**ALTON COAL DEVELOPMENT
C/025/0005 INITIAL RESPONSE
TO TECHNICAL ANALYSIS**

Re: C/025/0005 – Initial Response to UDOGM Technical Analysis (Task ID #3100),
 received April 22, 2009

C/025/0005Title: Initial Response to Division Technical Analysis - Task ID #3100

Water soluble selenium concentrations in overburden and underburden samples from the 200-acre proposed Coal Hollow Mine pit areas

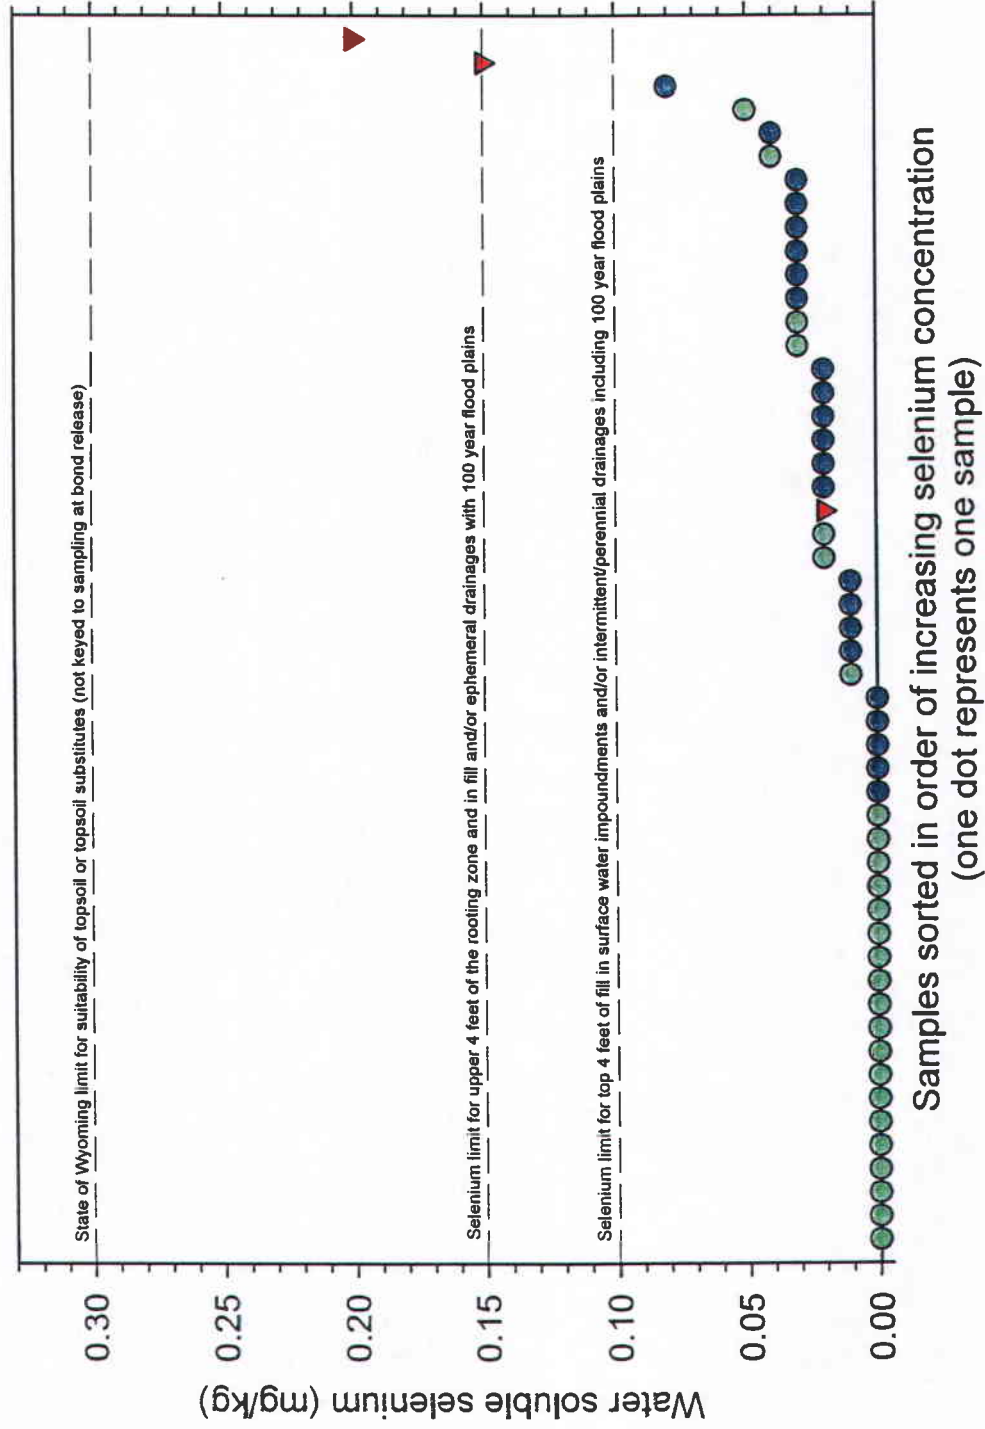
- **R645-301-731.300, Refer to Hydrologic Information Findings, p.125 of the TA:** Appendix 6-2 shows unacceptable levels of selenium in the zone below the coal and in the vicinity of CH-06-05, below 35 ft. where either insufficient sample provides no information on selenium levels or high levels of selenium were recorded. To ensure that selenium levels are adequately represented by these six core holes and that selenium levels in the surface and in the submerged water table remain low, the Division will require a selenium monitoring plan for soils and overburden during final placement. Refer to Attachment 1 of the Division's 2008 Guidelines for Topsoil and Overburden Handling when writing the Coal Hollow selenium monitoring plan. **and R645-301-121.200, Refer to Hydrology Operations Findings, p. 125 of the TA:** The Applicant states in Section 728.332 that Wyoming considers a value of 0.3 mg/kg selenium as suitable and between 0.3 and 0.8 mg/kg selenium as marginally suitable for topsoil and topsoil substitute. This statement is inaccurate and must be corrected. Refer to Acid/Toxic discussion above.

The Division's requirement for a selenium monitoring plan for soils and overburden does not appear to be based on any reasonable necessity for such a plan. A plot showing the concentrations of water soluble selenium in overburden and underburden materials from the proposed Coal Hollow Mine area is presented in Exhibit 6. Selenium concentrations were measured in both the alluvium overburden (26 samples) and Tropic Shale overburden (23 samples). In this figure, the selenium concentrations from the samples are plotted from left to right on the graph in order of ascending concentration. It is immediately apparent from the attached figure that none of the overburden materials exceed any of the selenium limits, even for the upper four feet of fill in perennial drainages. In fact, only a single overburden sample exceeds 0.05 mg/kg, or half of this most restrictive selenium limit. Assuming that run-of-mine material will be a mix of overburden from both the alluvium and the Tropic Shale and that the sample distribution is reasonably distributed, the average water soluble selenium concentration (based on the average of all overburden samples and using the conservative assumption that samples with a laboratory detection of <0.01 mg/kg concentration have a concentration of 0.01 mg/kg) would be about 0.018 mg/kg, which is only 18% of even the most restrictive selenium placement limit. Supplemental laboratory analyses for total selenium (which analyses would include any non-water-soluble forms of selenium) were also performed on the overburden and underburden samples. None of the samples analyzed for total selenium had concentrations exceeding the laboratory detection limit (5 mg/kg).

Somewhat higher concentrations were identified in the underburden (Dakota Formation) sediments underlying the coal seam, with concentrations ranging from 0.02 mg/kg, to 0.20 mg/kg. While some of the Dakota Formation underburden samples contained selenium concentrations that would not be suitable for the most restrictive placement in the upper four feet, there is no plan to extract the Dakota Formation materials from the mining areas. These materials are situated beneath the coal seam and there is no reasonable purpose for the mine to displace these materials. However, as a grossly conservative estimate, if it were assumed that fully a quarter of all the fill material from the mine were to be composed of the Dakota Formation with the highest measured selenium concentration (0.2 mg/kg), it would be calculated that the composite run-of-mine material would have a water soluble selenium concentration of only about 0.063 mg/kg, which would then, in terms of selenium concentration, be suitable for placement in even the most restrictive areas in the upper four feet of fill.

Comparison of average measured spring flows with
spring flows claimed in the water rights application

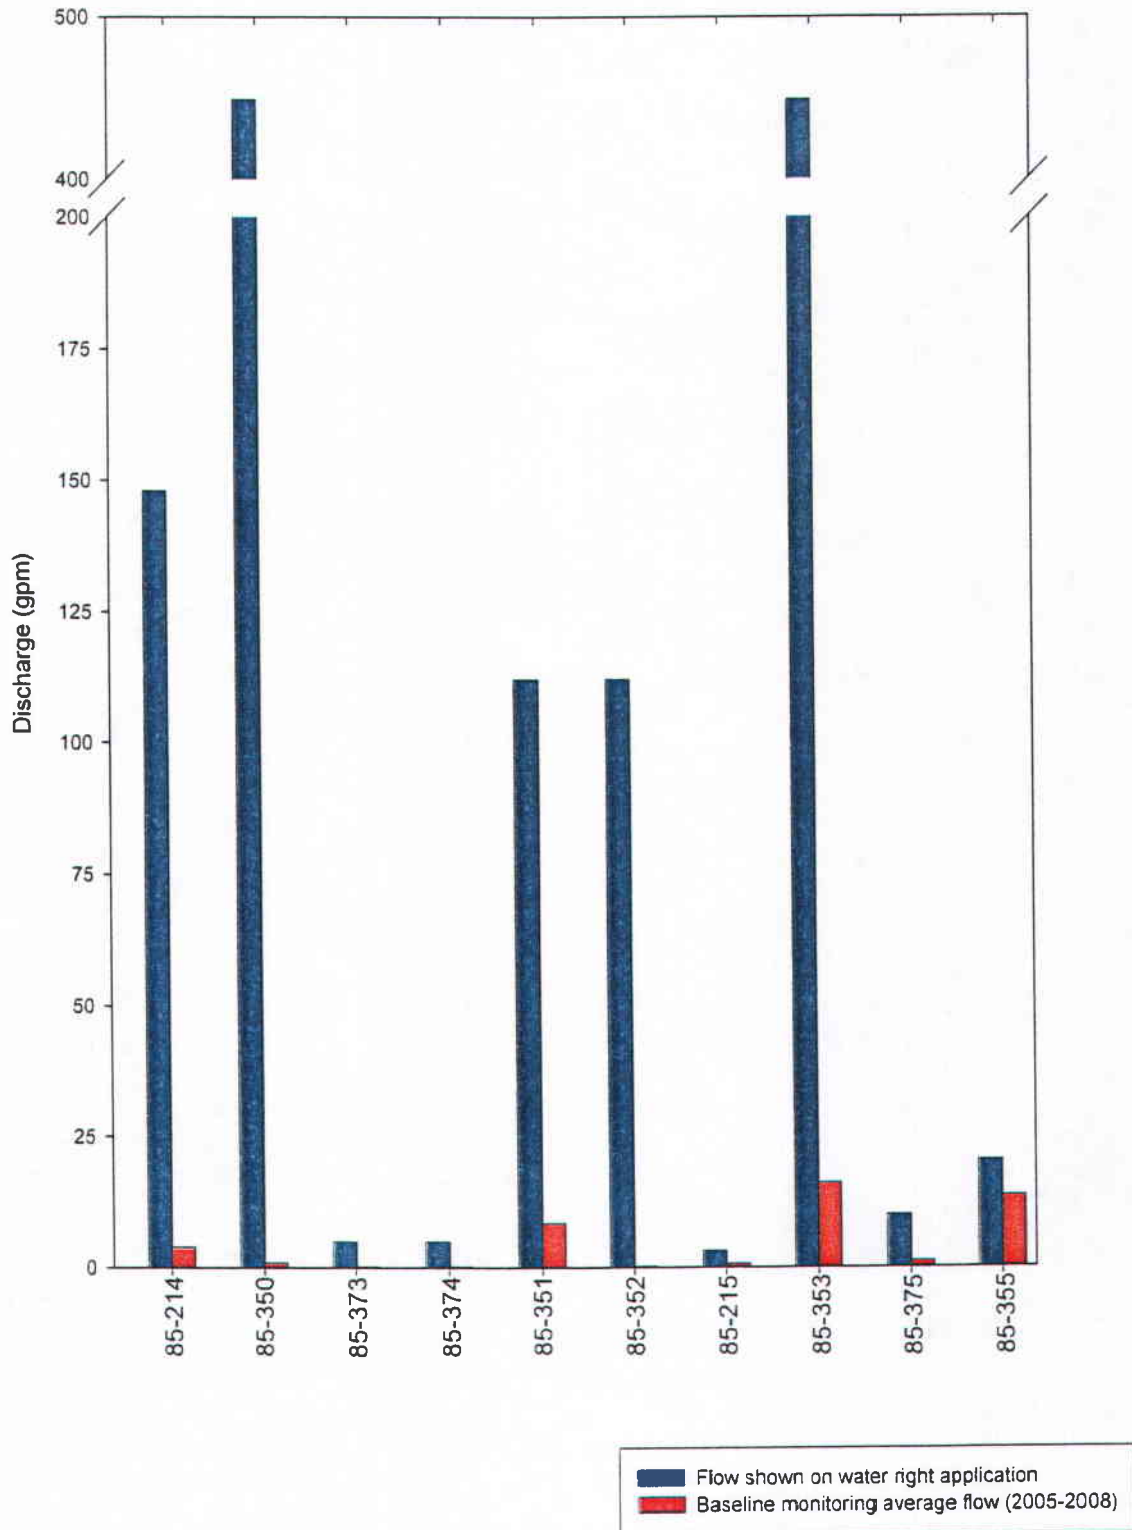
The Division's discussion of water rights fails to clarify this situation and implies that such large flows are actually occurring, when baseline monitoring information presented in the MRP clearly indicates that this is not the case. These statements should be clarified or removed from the TA.
